TOWN OF WINCHENDON

Conservation Commission

Regular Meeting/Public Hearing

July 9, 2020

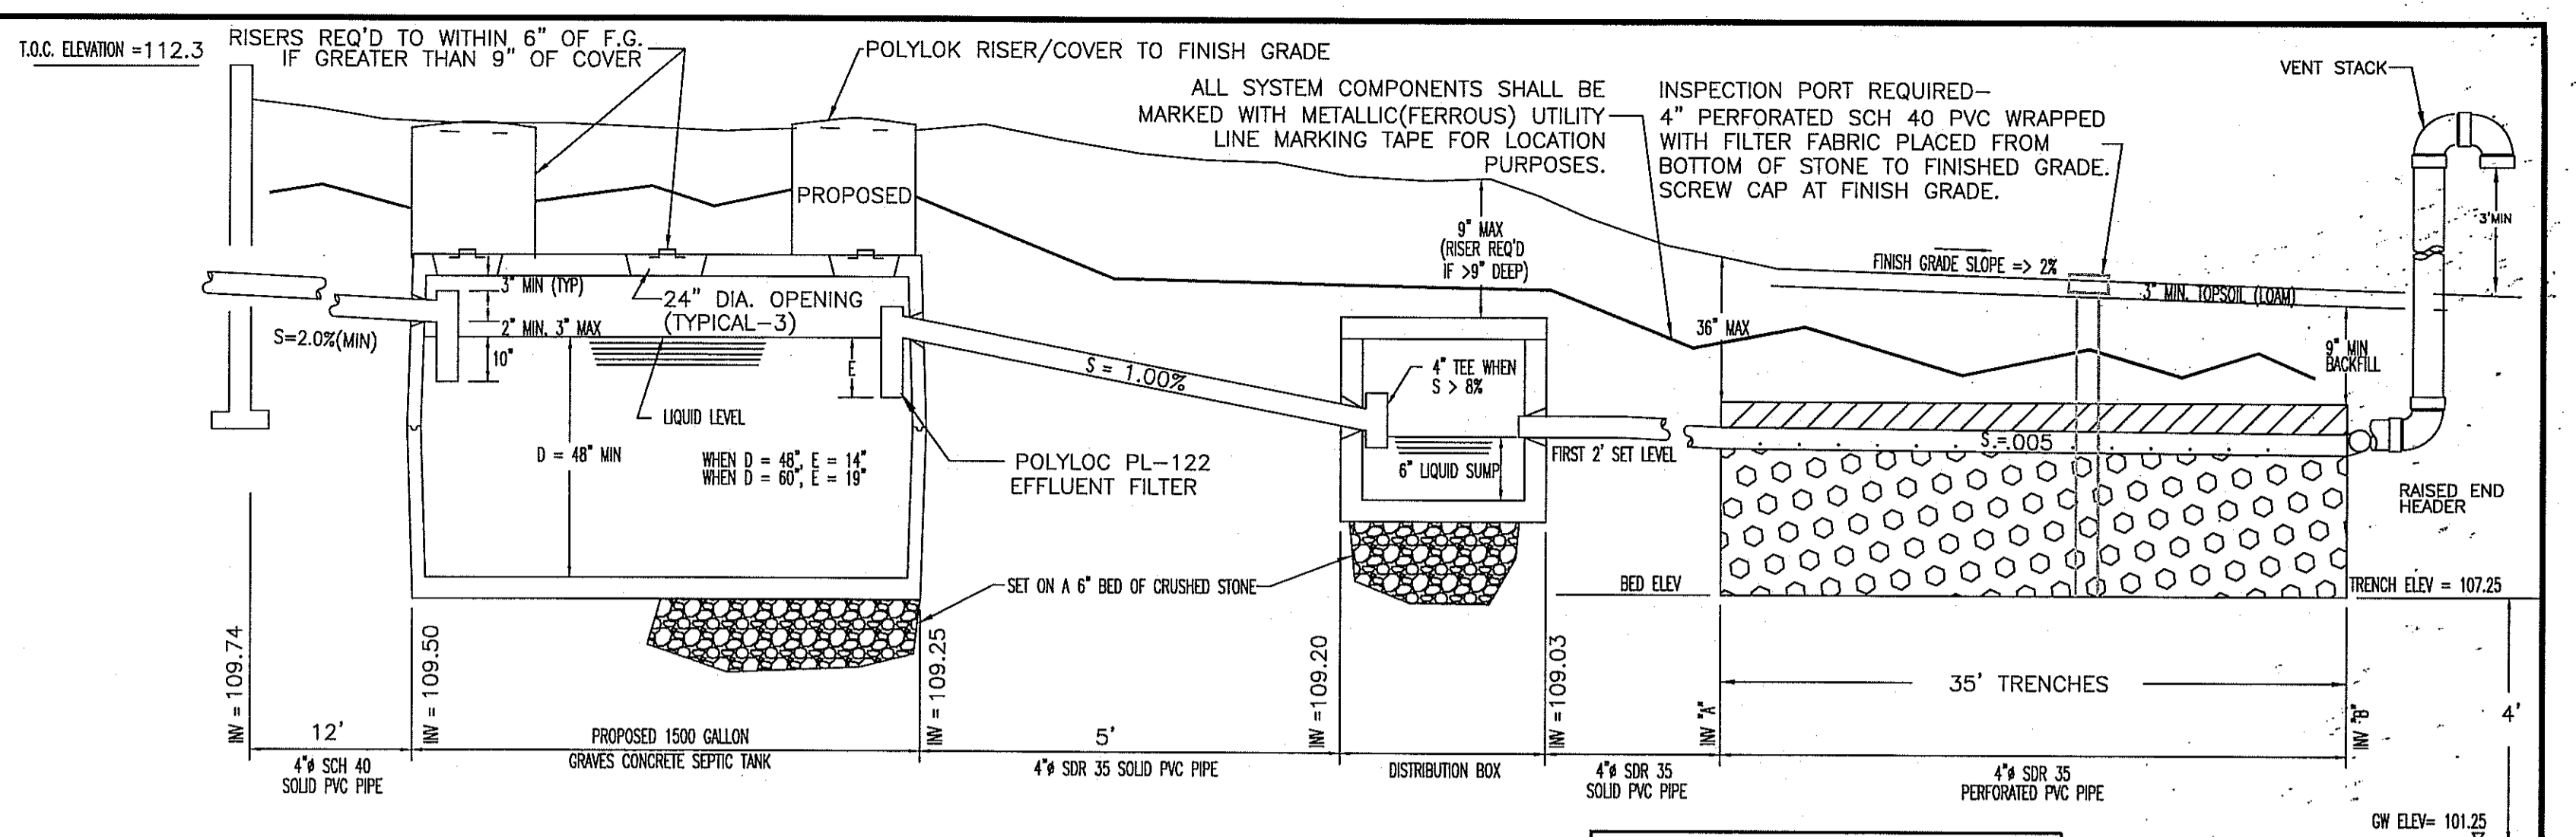
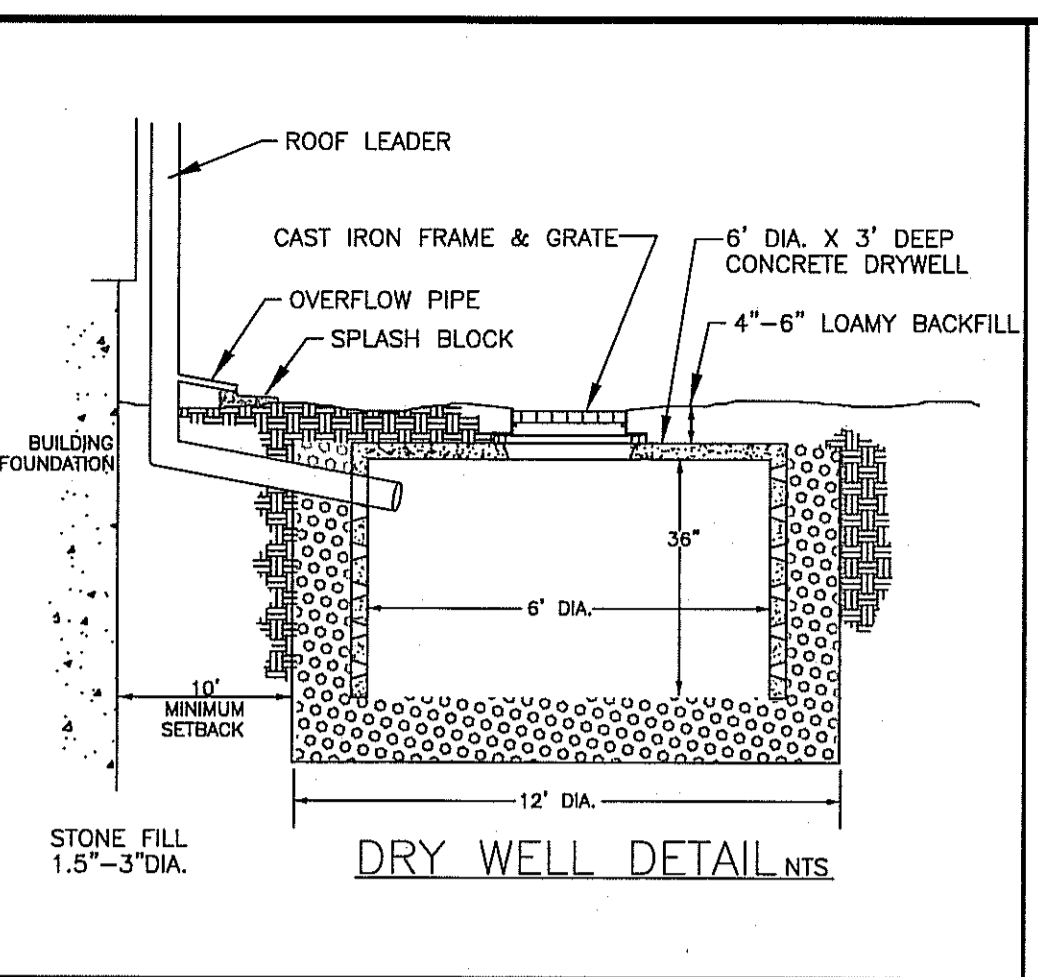
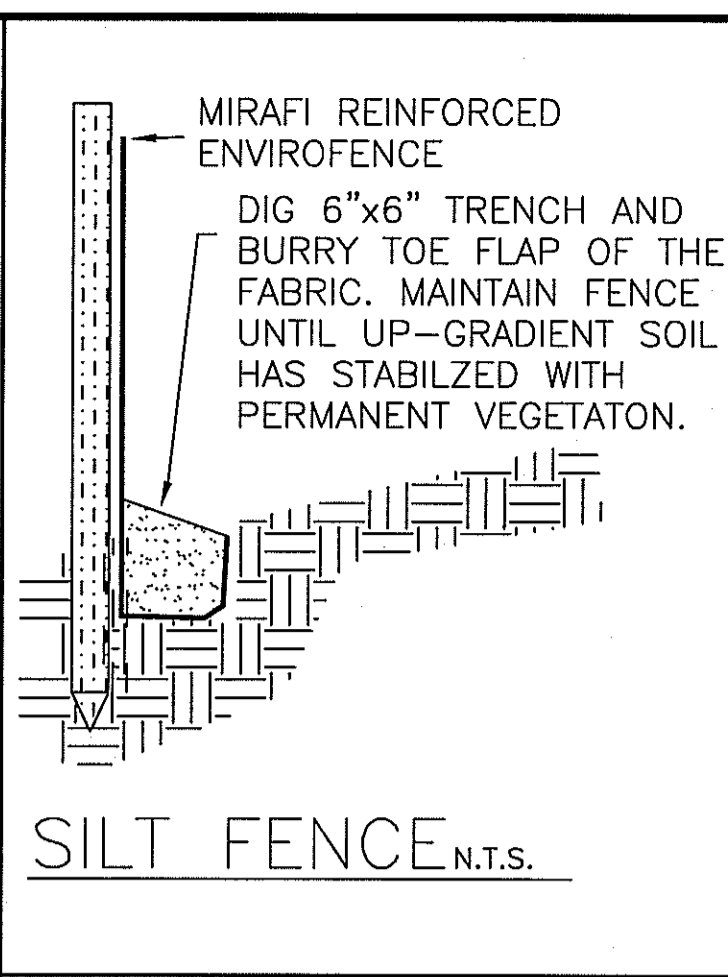
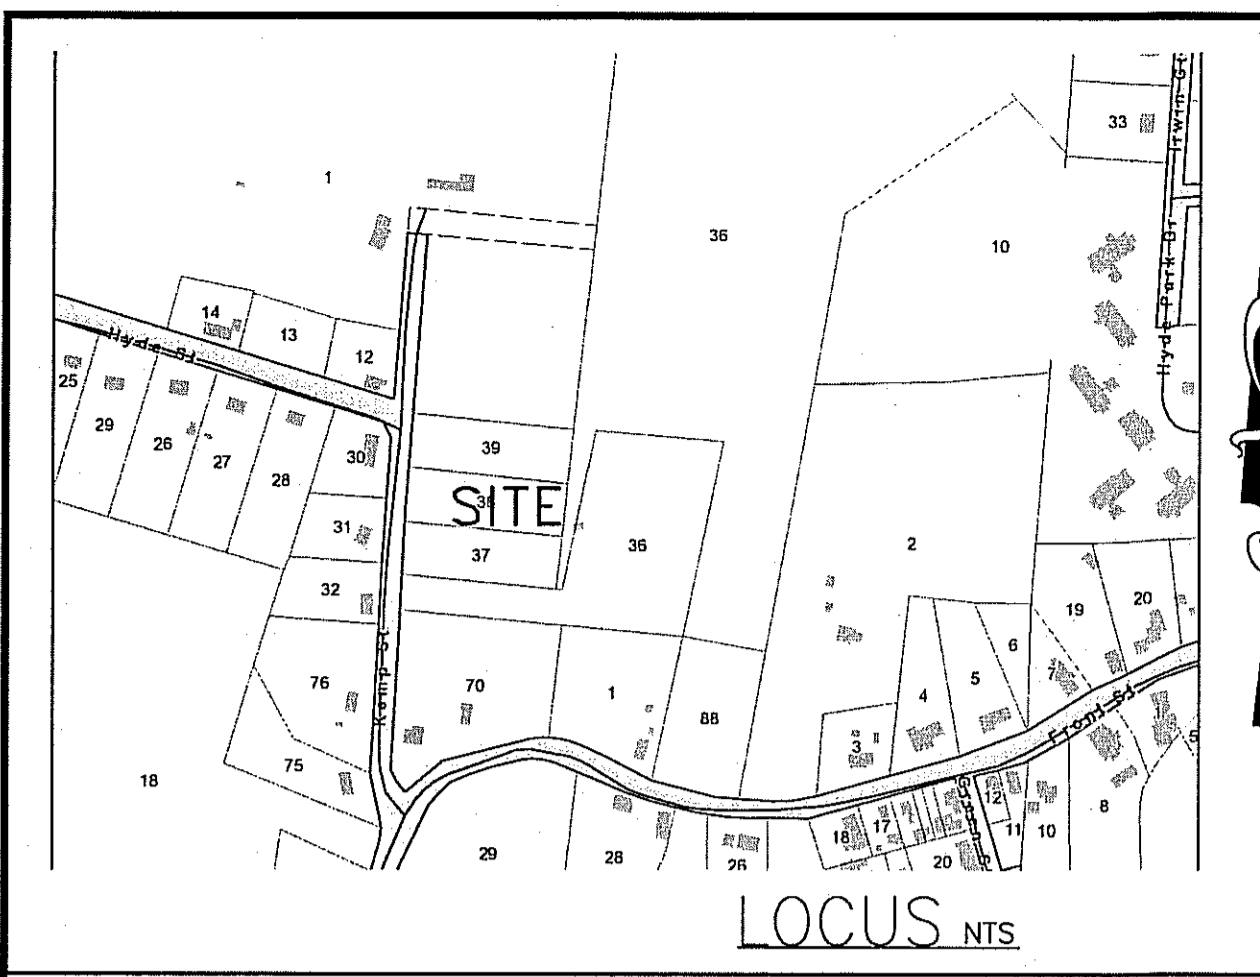
1. The Applicant has adjusted the plans to reduce the scope of work inside the 100-foot buffer zone. On behalf of the abutters the following changes are requested to be considered. For clarity mark-ups of the plans has been provided:

3. The Applicant has indicated that disturbance will be less than 40,000 sf total for the two parcels and therefore the Project is not subject to the EPA's National Pollution Discharge Elimination System (NPDES) Construction General Permit (CGP). A review of the plans indicates that approximately 46,000± sf of disturbance appears to be shown. We request that the Applicant revise the plans to show a limit of work that clearly limits disturbance to 40,000 sf.

SEPTIC SYSTEM & NOI SITE PLAN
MAP-5B1 LOT-37
49 KEMP ST; WINCHENDON, MA
PREPARED FOR:
BARKLEY ENTERPRISES, LLC
1032 N.H. ROUTE 119
RINDGE, NH 03461

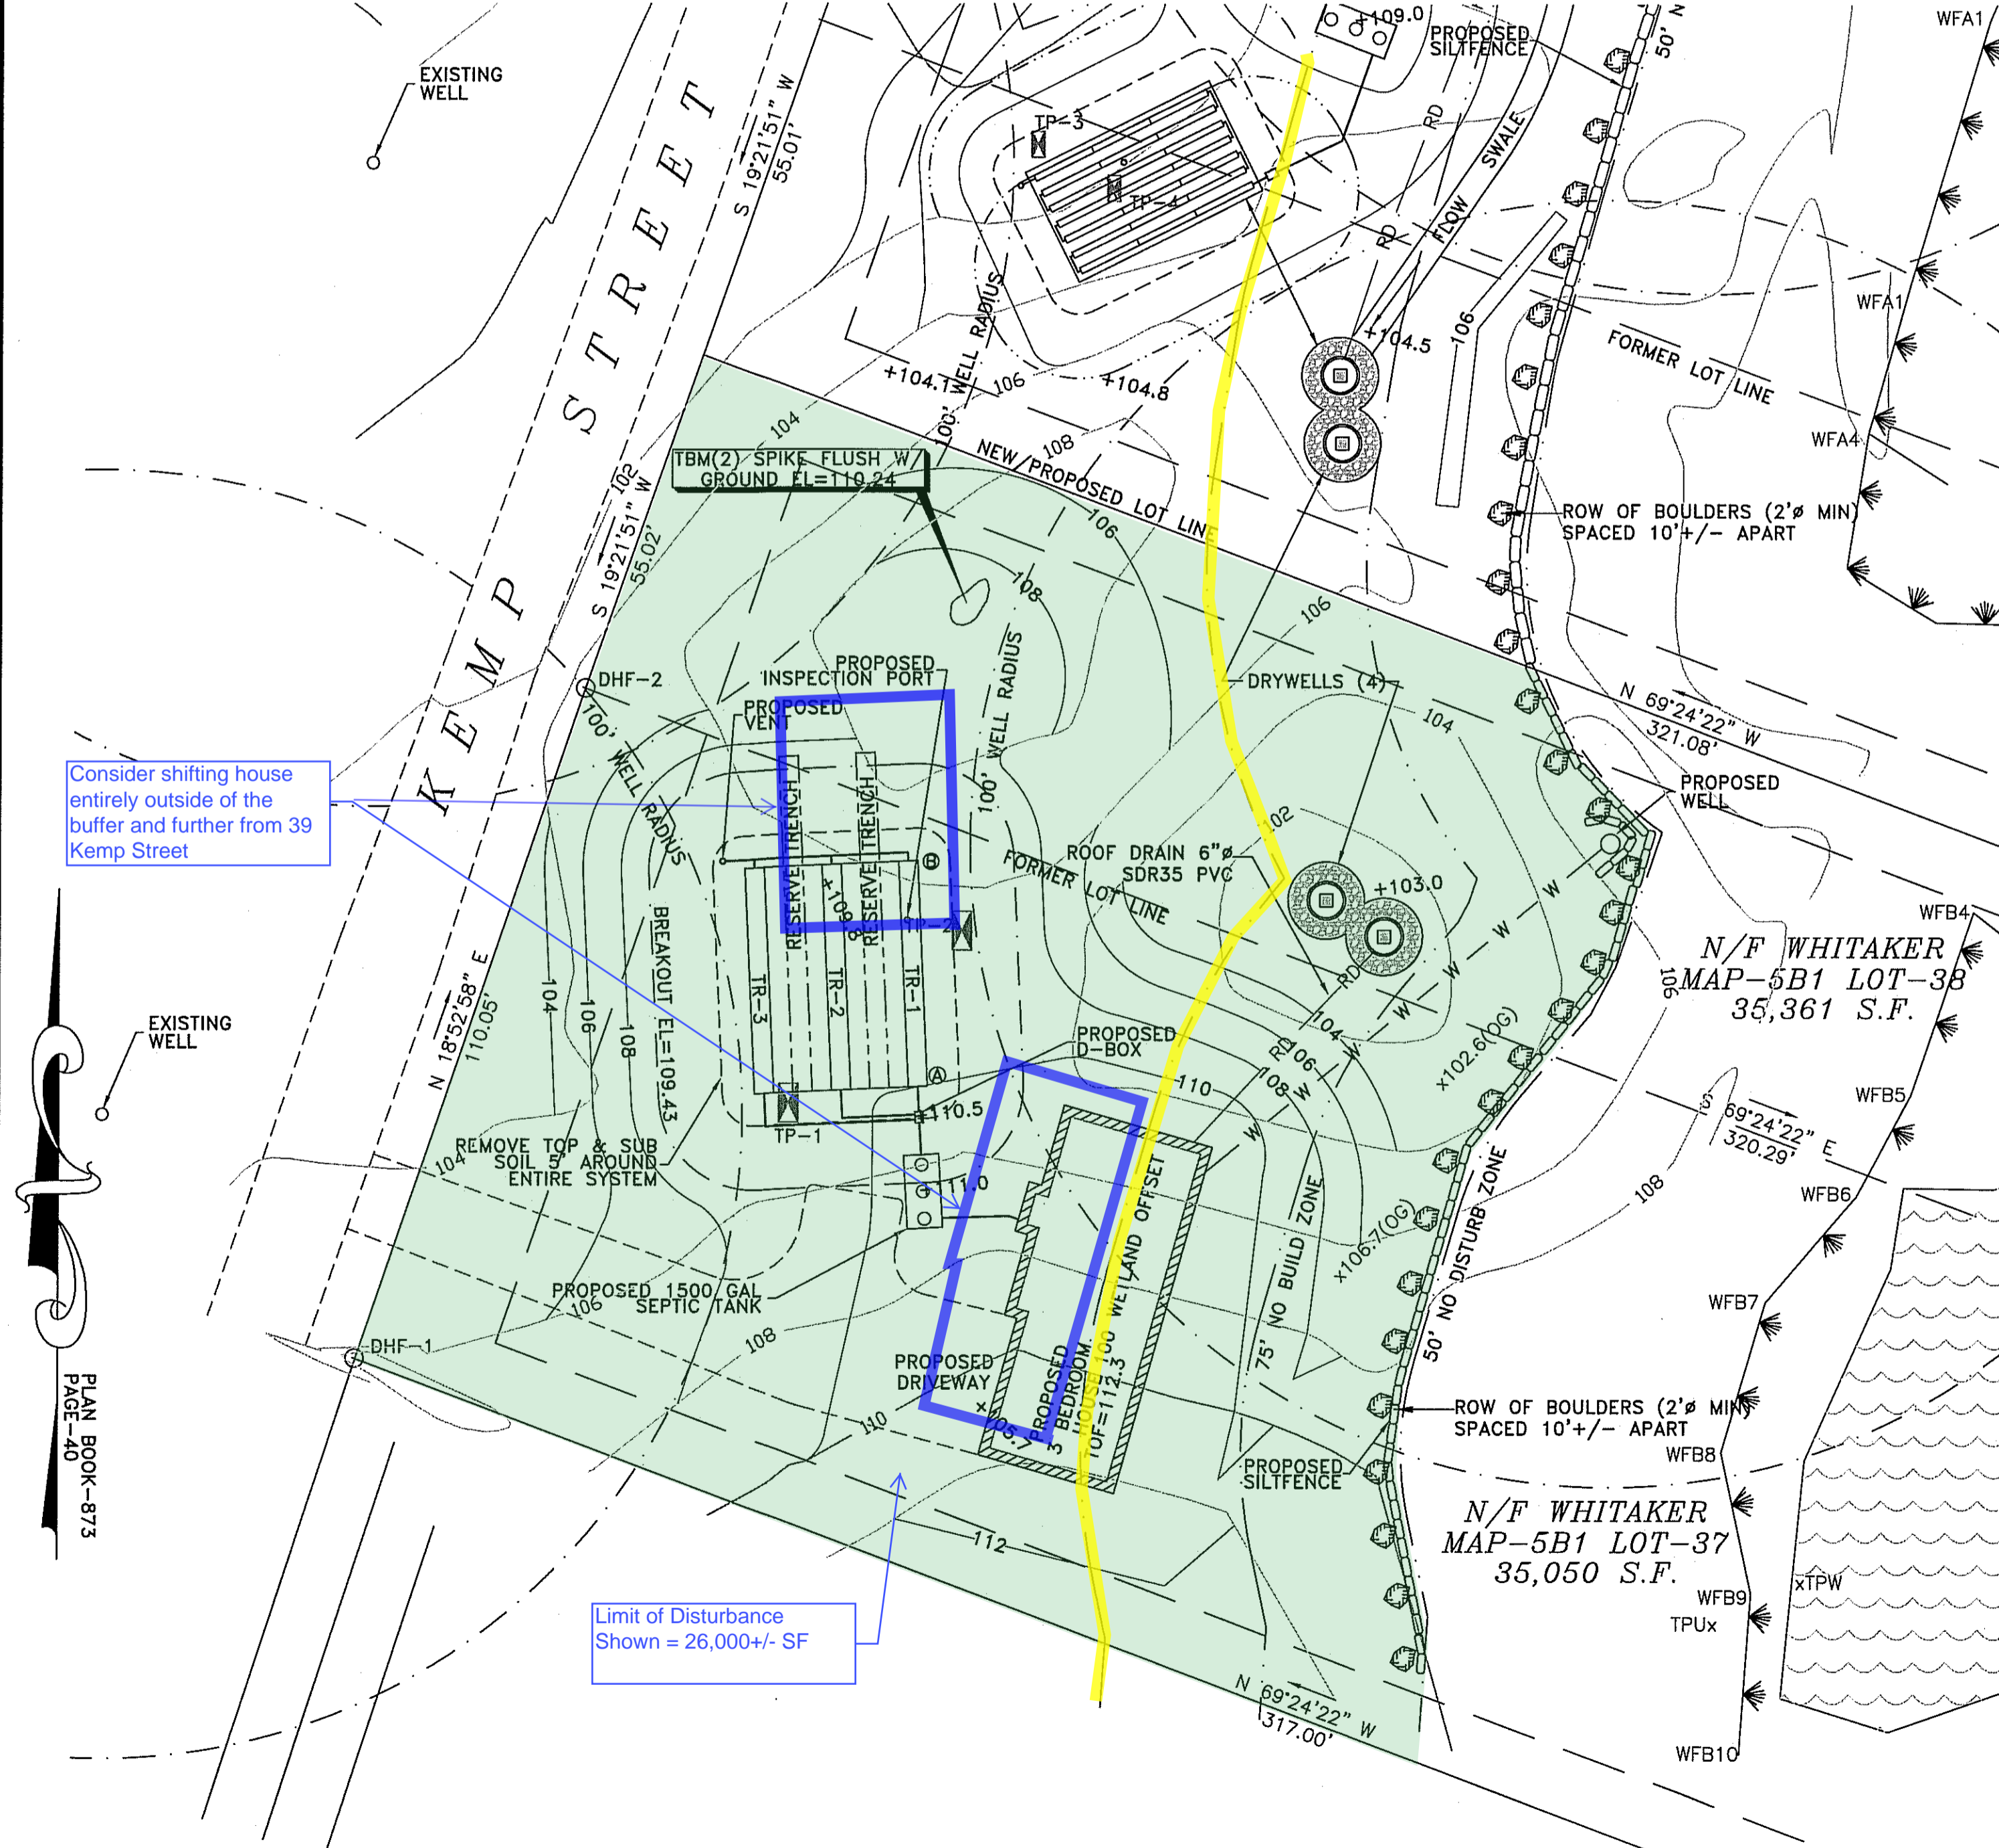
P. Grasewicz outlined the intent and summarized the revised plans for these two new residential structures. Both homes have been pulled out of the 100' buffer to the maximum extent practical and septic systems have been adjusted to accommodate these shifts. Drainage design has been updated to include two concrete recharge basins on each parcel and eliminate the need for maintenance easements.

Erosion controls will be installed at the wells and along the 50' wetland setback line. No clearing work will be done beyond this 50' setback and boulders shall be permanently placed along the 50' setback.

The limit of 40,000sf combined site disturbance was acknowledge and P. Grasewicz will update the plans prior to construction to indicate additional areas where there will be no disturbance. Current plans show approximately 46,000sf of disturbance.
